# Issue with implementation of “full deskew” for Clause 177 (comment #159 against D1.1)

Gary Nicholl – Cisco

IEEE 802.3dj Logic/Optics ad-hoc, 17 Oct 2024

Figure 177-2—Functional block diagram

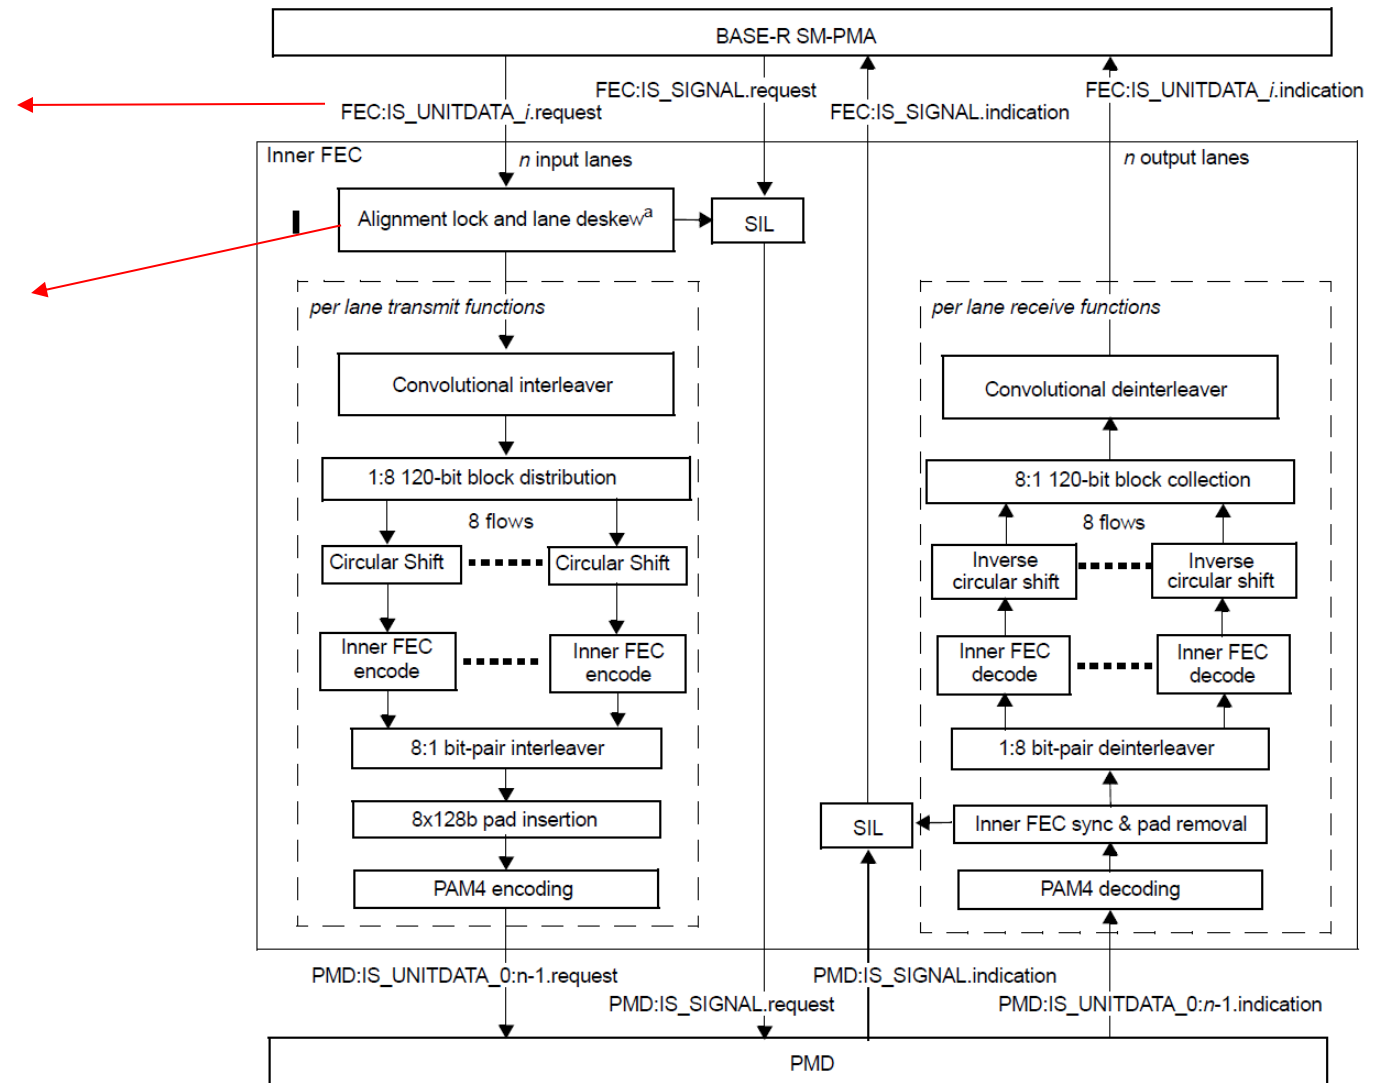
Newly added “alignment lock and lane deskew” function (in response to comment #159).

- In order to perform the PCS lane deskew function the 200G input lanes would first have to be symbol-demuxed back to PCS lanes (essentially un-doing the symbol muxing of the SM-PMA layer above)
- Then deskew performed on the PCS lanes
- And finally, the PCS lanes symbol-muxed back to 200G lanes (repeating the function of the SM-PMA layer above).
